P.20-1528/RF

**PLANNING APPLICATION APP/21/00189
BROCKHAMPTON WEST, HARTS FARM WAY, HAVANT, PO9 1HS
LANDSCAPE RESPONSE NOTE**

APPENDIX 1, SITE TOPOGRAPHY PLAN (GREENHATCH DWG. 38147_T)

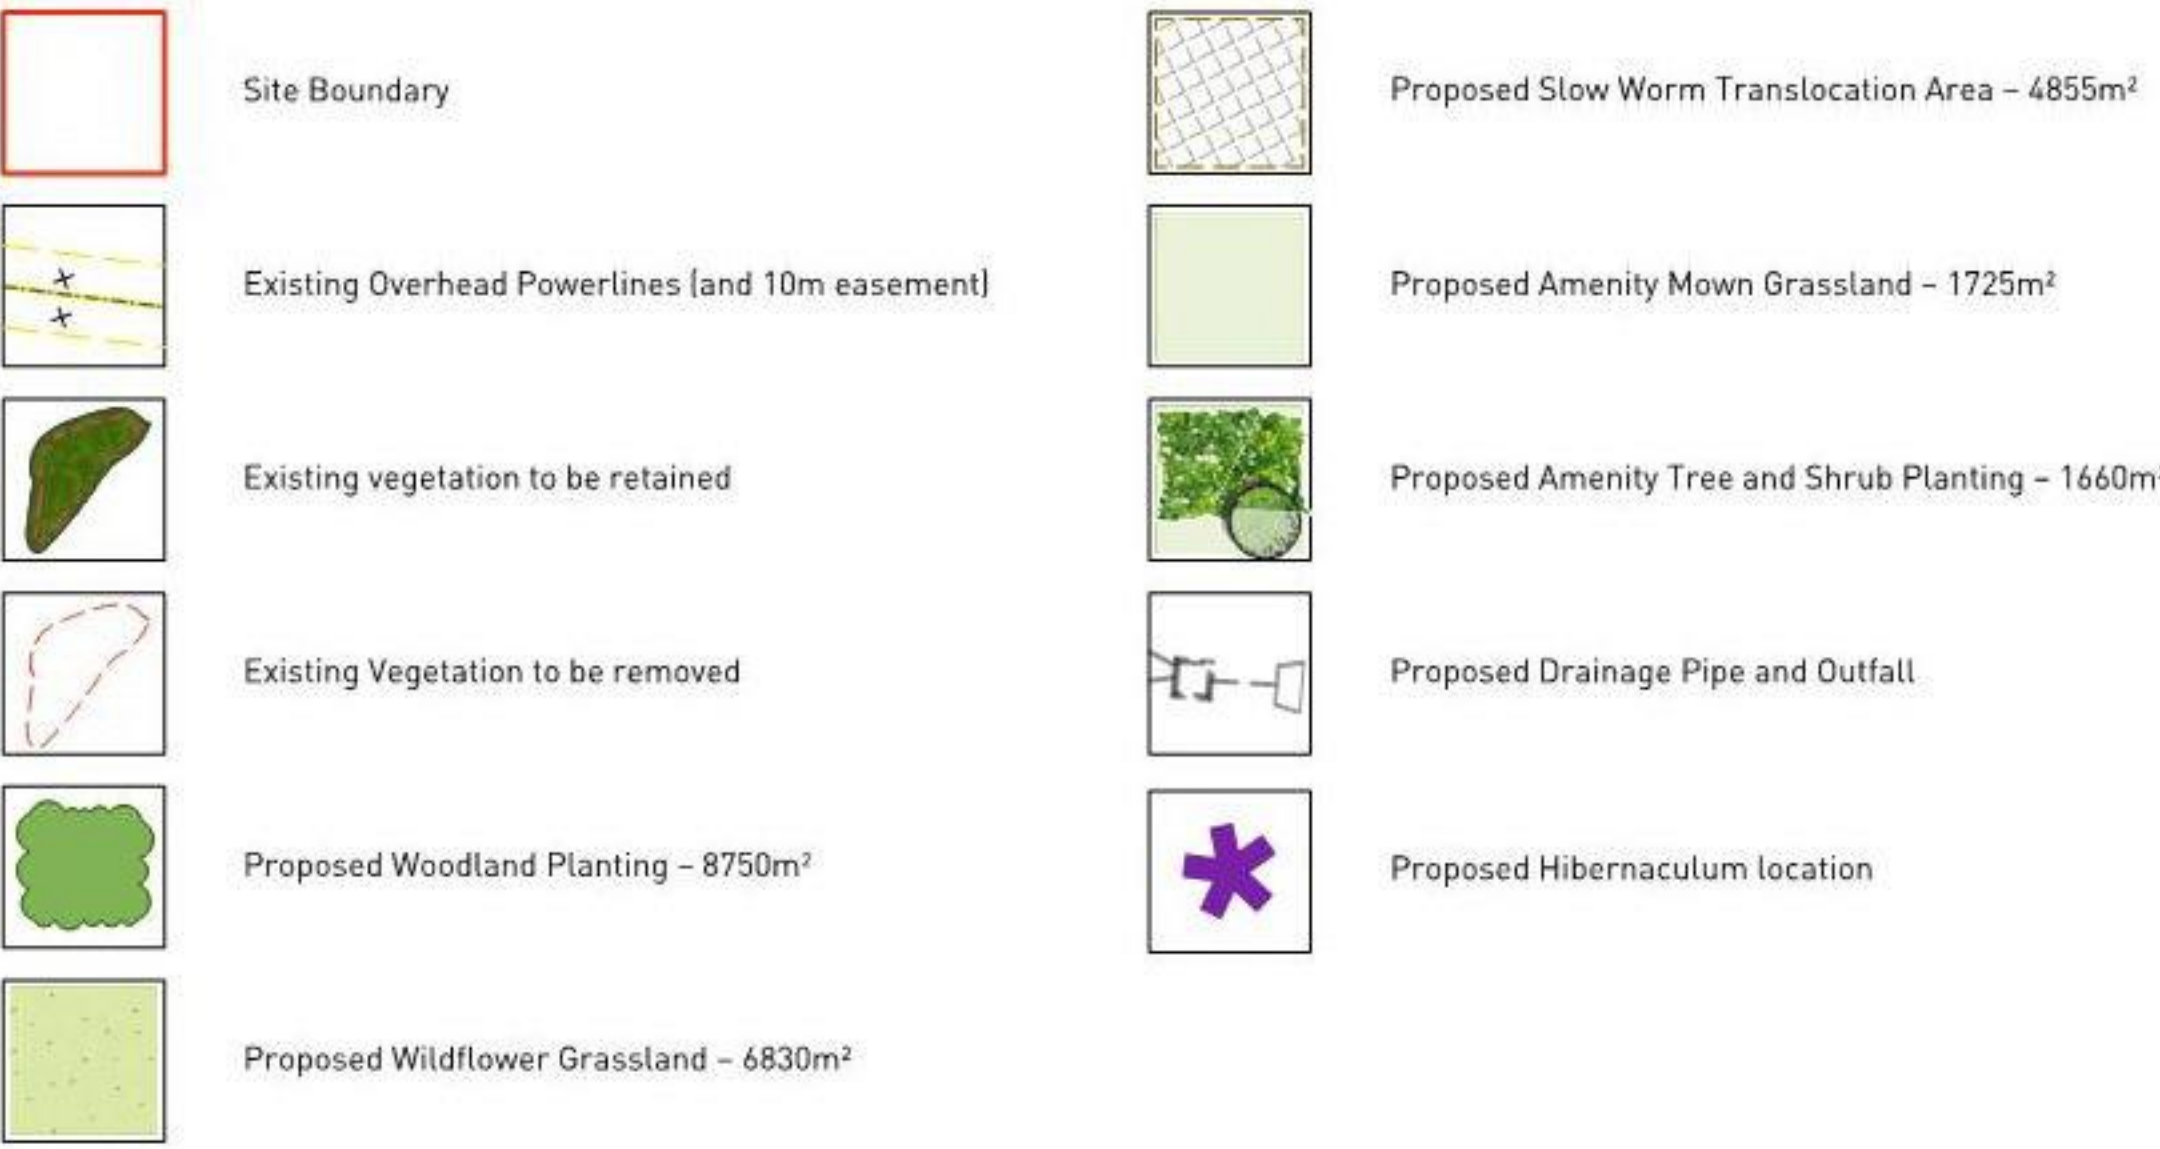
"Given the sites topography (7.16m 15.20m) we require details on proposed cut and fill to understand final building heights in relation to the proposed levels as this will have a significant impact on any landscape mitigation strategy to soften the development into the landscape."

The topographical survey shows the existing site levels and is provided in Appendix 1 (Greenhatch dwg. 38147_T). The site is located within an area of former landfill therefore the proposals have sought to leave this in situ as far as possible. To ensure that the retained landfill will not give rise to any impacts on the surroundings, an enhanced capping layer or slab will be provided to make the land commercially viable as an employment allocation and to secure a betterment of the site in respect of potential contamination risks.

The landfill material is relatively close to the surface on both the eastern and western parts of the site, which means that areas of cut have been minimised. This means that forming a plateau on the western part of the site will need to be achieved by building lower parts with fill rather than a cut of the higher areas. If the site formation levels are to be achieved by additional areas of cut, this will lead to greater disturbance of landfill material which would then need to be taken offsite to an alternative landfill location, which is not considered to be sustainable.

The ground levels within the site have already been raised relative to its surroundings through the previous landfill operations. The levels across the site vary considerably but are generally around 10 - 11m AOD on the western section, with the car parking area and Harts Farm Way access being the lowest points on the site with levels around 7 - 9m AOD. The eastern part of the site is characterised by a mound with significant variations ranging between approximately 10 - 15m AOD where a greater volume of landfill waste has been placed.
